Subject: AP1000 Response to Requests for Additional Information (TR 44)

Westinghouse is submitting a revised response to the NRC requests for additional information (RAIs) on AP1000 Standard Combined License Technical Report (TR) 44, APP-GW-GLR-026, "New Fuel Storage Rack Structural/Seismic Analysis." This RAI response is submitted in support of the AP1000 Design Certification Amendment Application (Docket No. 52-006). The information included in the response is generic and is expected to apply to all COL applications referencing the AP1000 Design Certification and the AP1000 Design Certification Amendment Application.

Response to Requests for Additional Information on Technical Report 44

Figure TR44-11.1 New Fuel Acceleration Time History for EW Direction

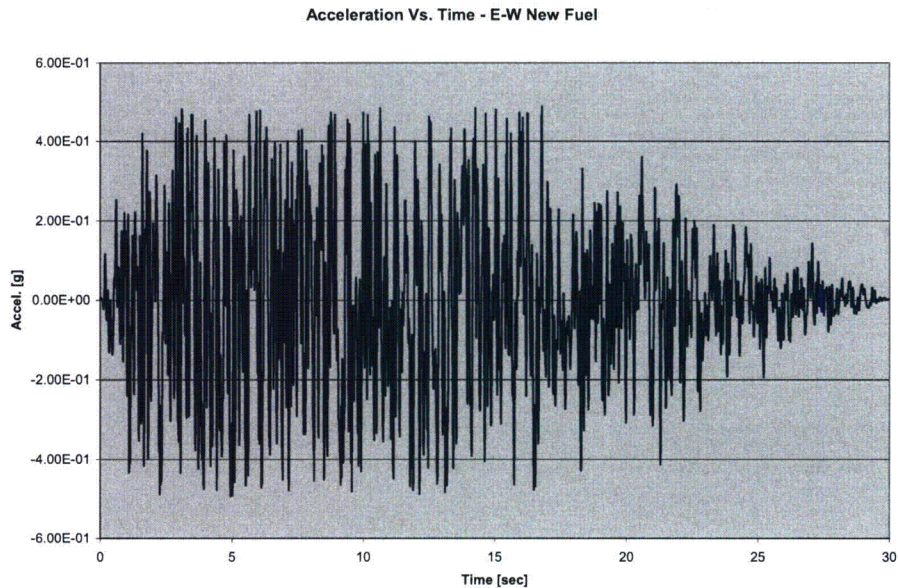
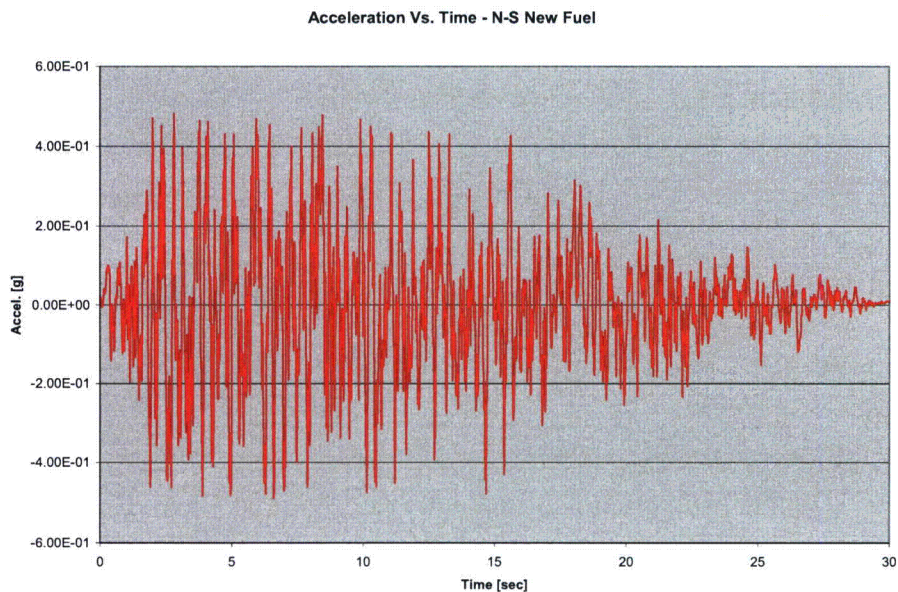
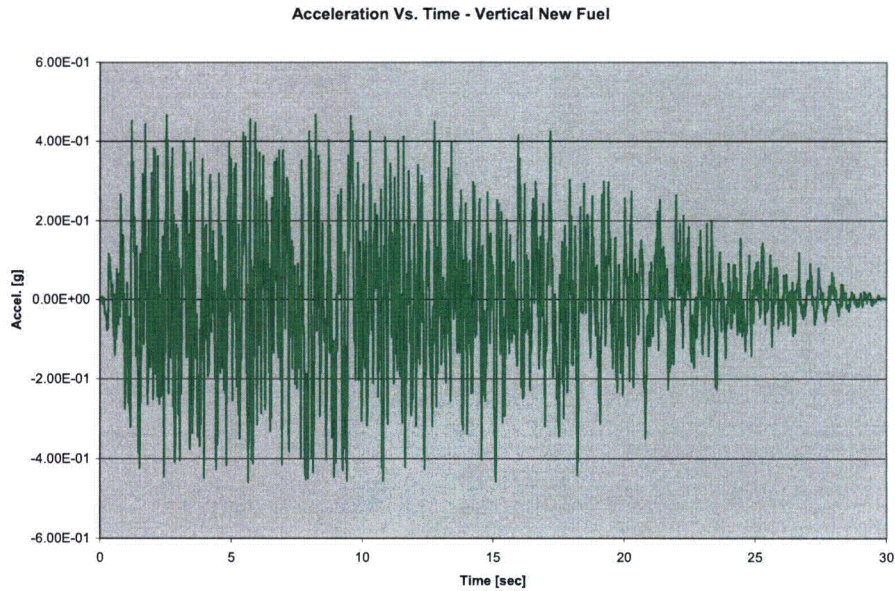
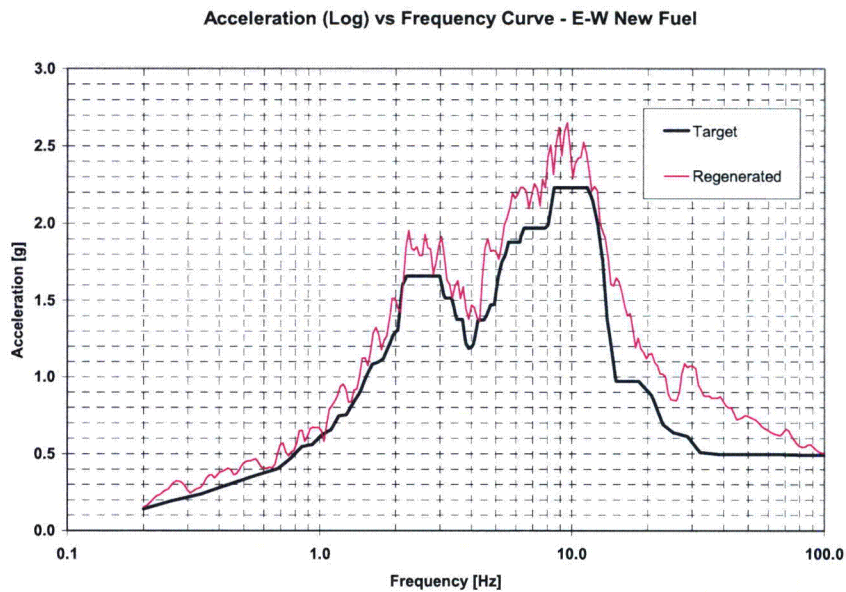
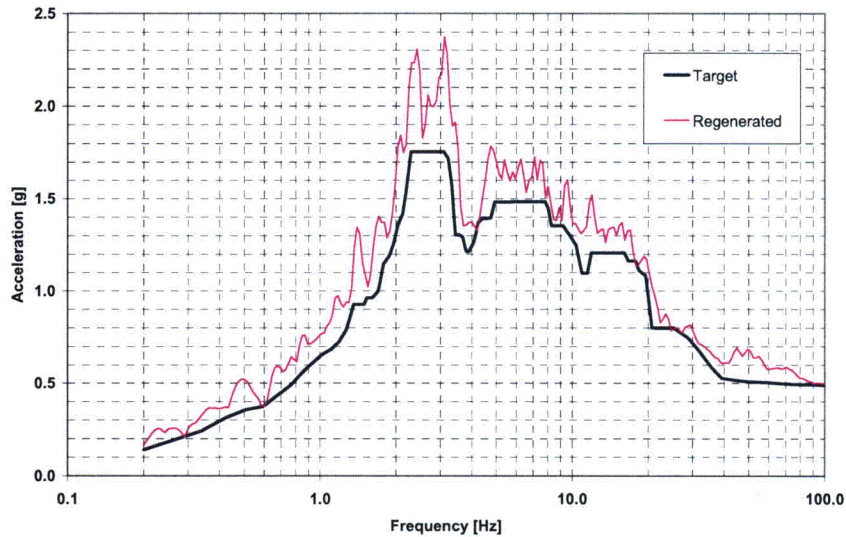
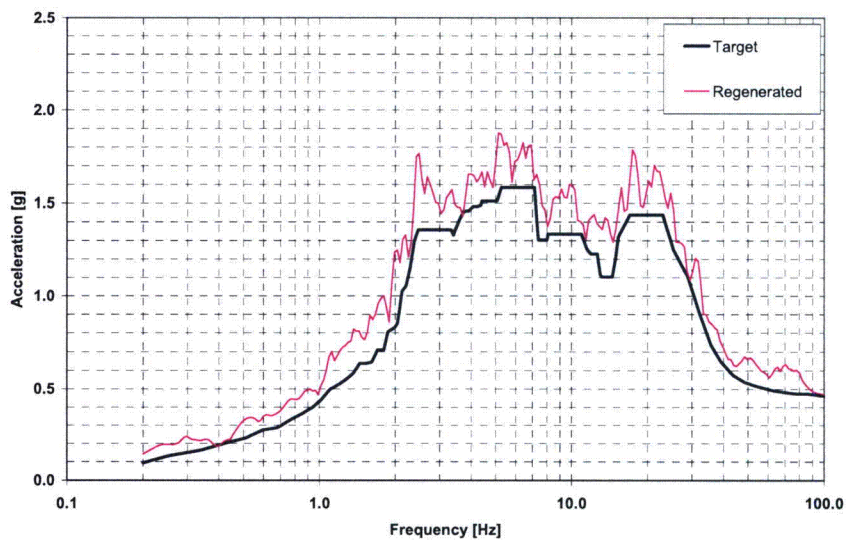
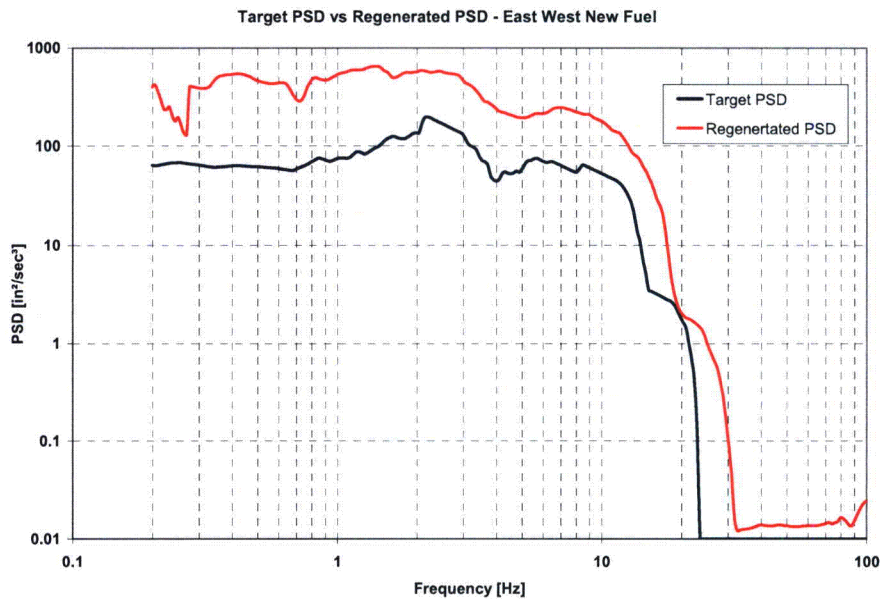
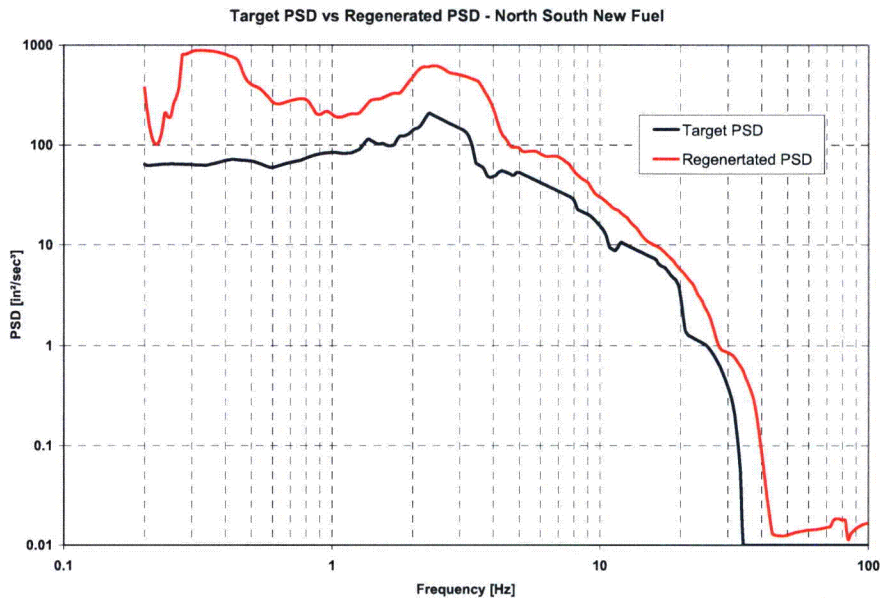
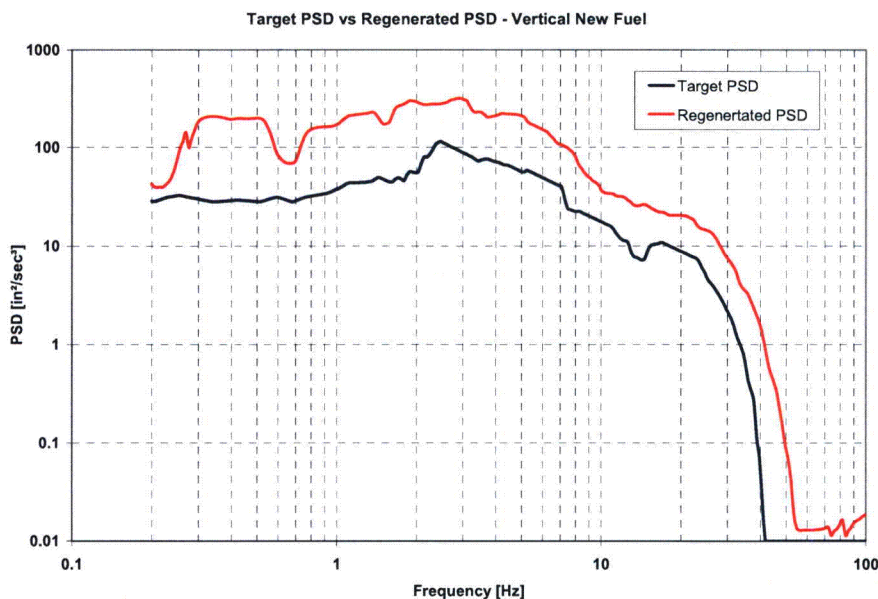
- (d) For the synthetic time histories, provide plots of the three time histories, the cross correlation coefficients, the comparisons of the spectra from the synthetic time histories to the enveloped target response spectra, and the comparisons of the power spectral density plots to the target power spectral density function associated with the target response spectra.

d) The synthetic time histories, the response spectrum curves, and the power spectral density plots for the new fuel storage vault inside the Auxiliary and Shielding Building (ASB) at Elevation 116' - 6" (the bottom of the new fuel vault is at Elevation 118' - 2.5") are provided in Figures TR44-11.1 through TR44-11.9. The cross correlation coefficients for the three orthogonal components (East-West, North-South, and Vertical) of the "New Fuel" synthetic time histories are summarized in the table below.

Figure 9.1-1 (Sheet 1 of 2)

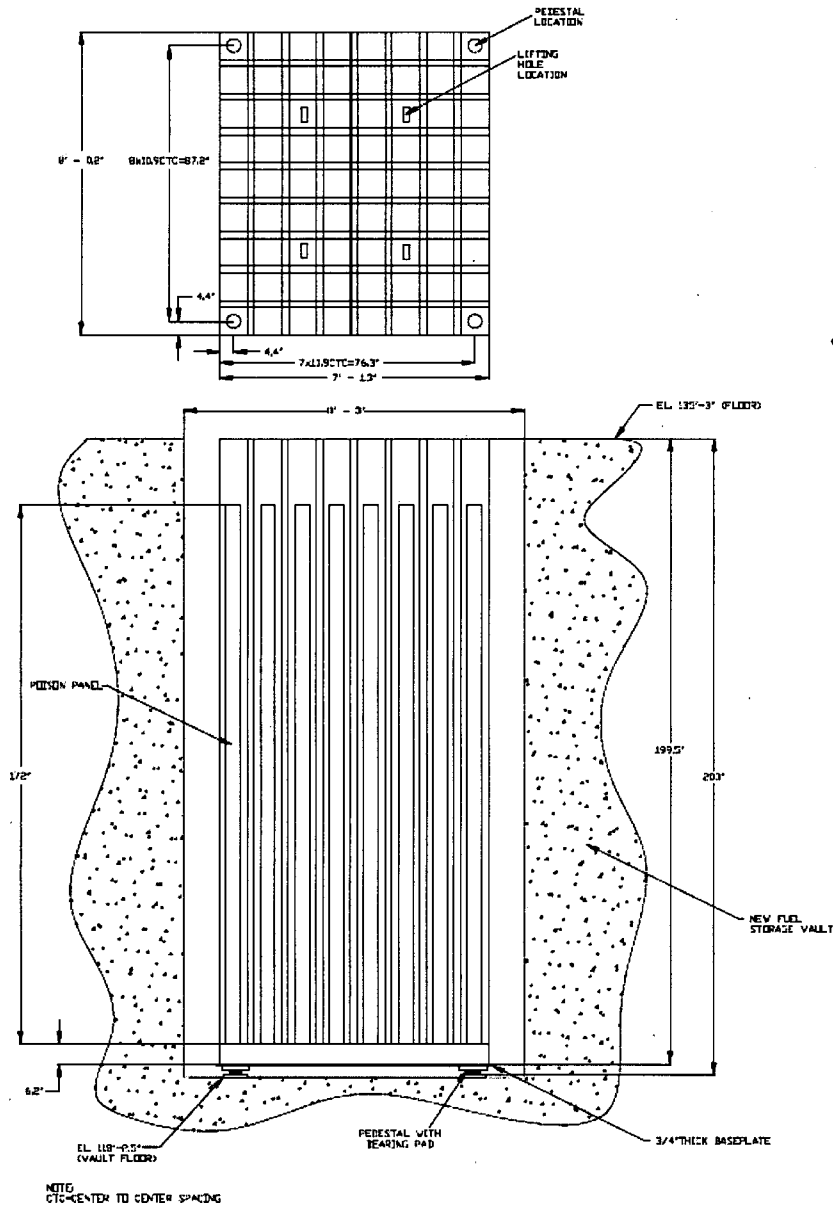
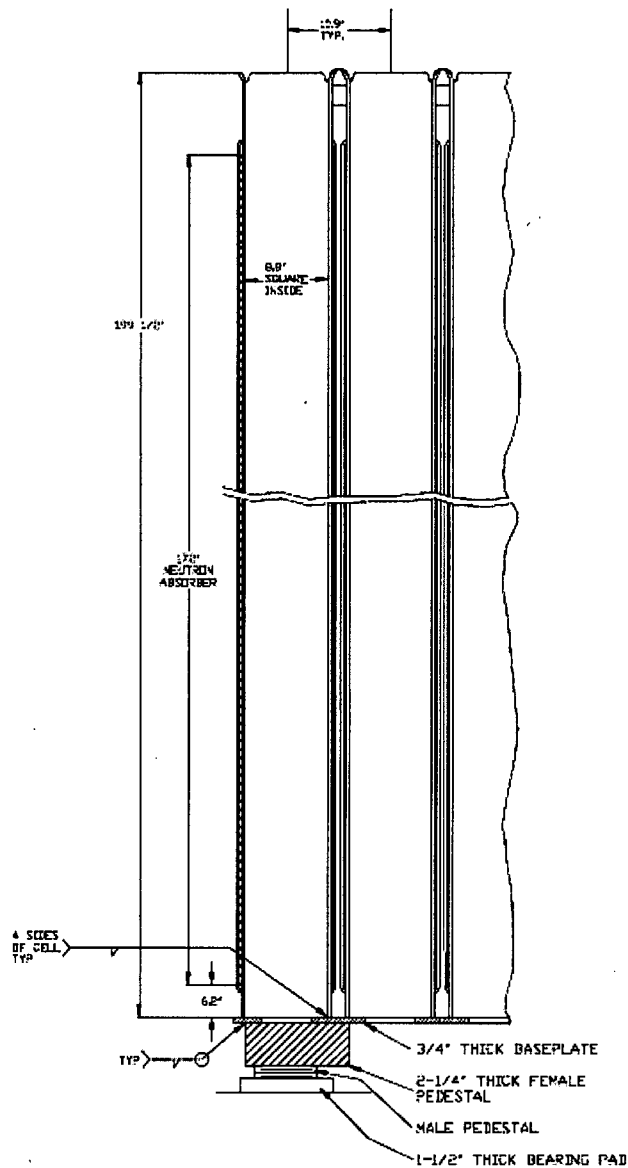
In the markup of the DCD, provided in Section 5 of the topical report, Figure 9.1-1, New Fuel Storage Rack, is identified for deletion. Please explain why you are deleting this figure. This figure should be retained in the DCD.

We are in agreement. Revision 16 of the DCD will have a revised Figure 9.1-1 New Fuel Rack Layout. This figure will show the new fuel rack configuration in plan and elevation views identifying significant features and dimensions.

Figures 9.1-1 (Sheet 1 of 2) and Figures 9.1-1 (Sheet 2 of 2) are changed as shown below.
